**Technical Review Report
for the
Safety Analysis Report for Packaging
Model 9977
S-SARP-G-00001
Revision 2
August 2007**

Compiled by
A. DiSabatino, R. Hafner, and M. West
**Packaging and Transportation Safety Group
Energy & Environment Directorate
Lawrence Livermore National Laboratory
September 30, 2007**

This Technical Review Report (TRR) summarizes the review findings for the Safety Analysis Report for Packaging (SARP) for the Model 9977 B(M)F-96 shipping container. The content analyzed for this submittal is Content Envelope C.1, Heat Sources, in assemblies of Radioisotope Thermoelectric Generators or food-pack cans. The SARP under review, i.e., S-SARP-G-00001, Revision 2 (August 2007), was originally referred to as the General Purpose Fissile Material Package.

Figure 5.3.1 Gamma Source Spectrum

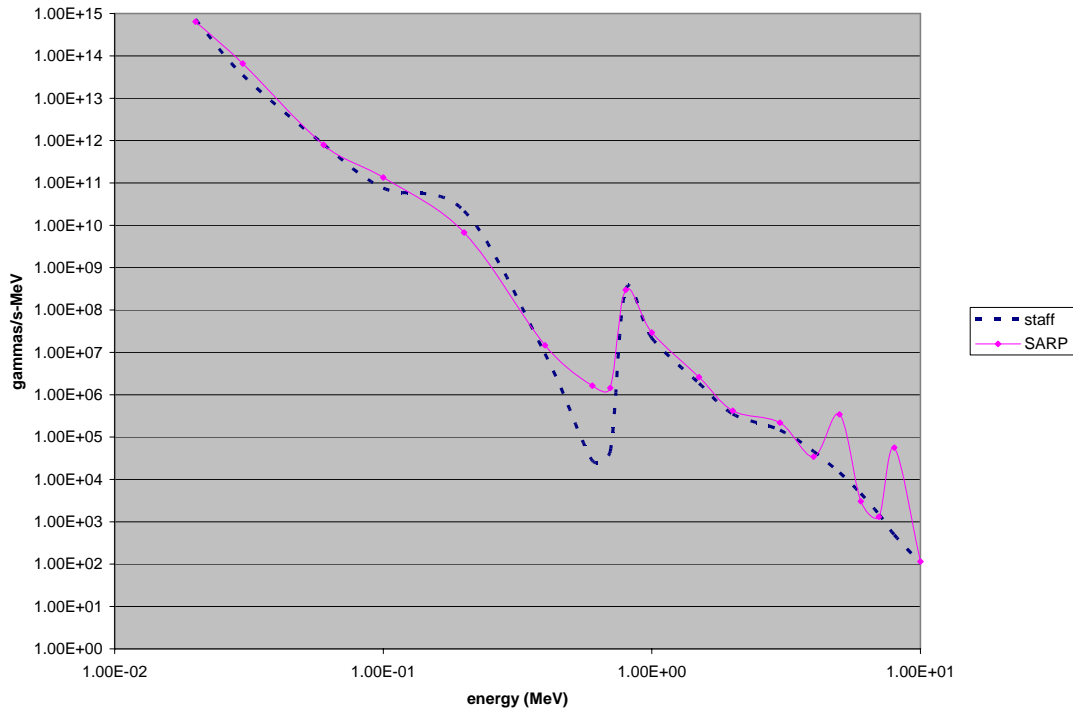
The Staff used ORIGEN-S to determine the gamma source term. A comparison of the gamma source spectrum is presented in Figure 5.3.1.

Figure 5.3.2 Neutron Source Spectrum

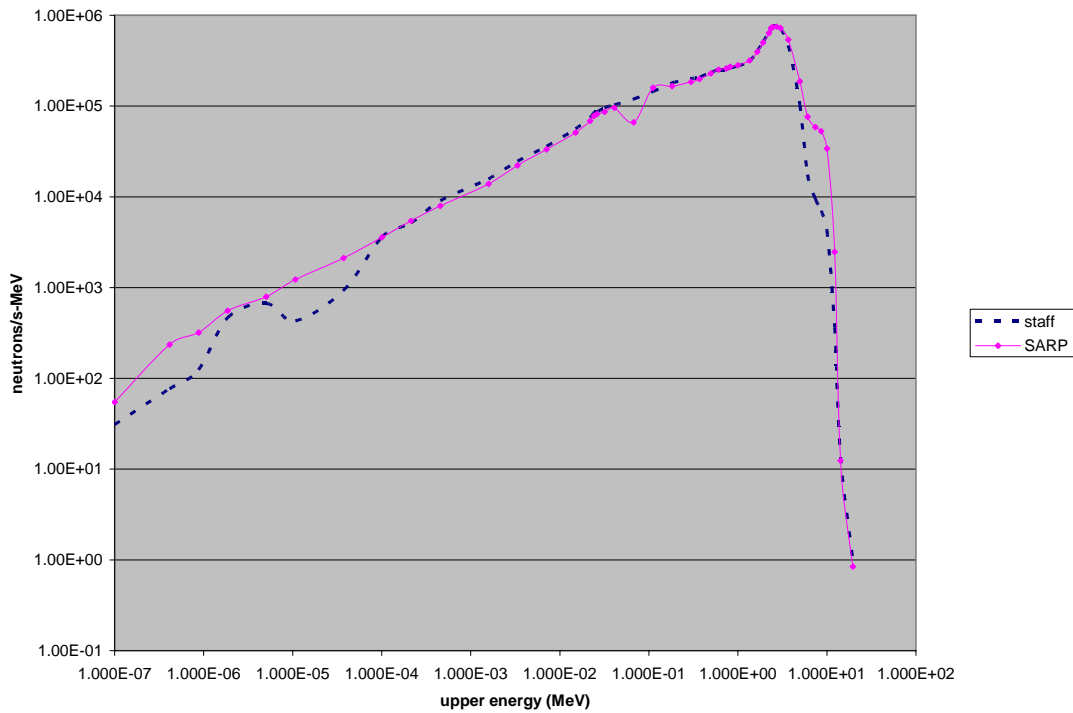
A comparison of the neutron source spectrum is presented in Figure 5.3.2.

The neutron source term generated by the Staff compares well with that in the SARP generated by the applicant, except at low energies and at very high energies (between 6 and 12 MeV). The SARP data shows larger populations at these energies. However, the discrepancy in the low energy region is not significant. In the most important region of the spectrum, between 0.1 MeV and 6 MeV, the agreement between the two independent calculations is good (within 10%). The

overall source strength calculated by the Staff is 1.86×10^6 neutrons/s, compared with 2.24×10^6 neutrons/s calculated by the applicant, leading to a 20% conservatism in the applicant's neutron source term.
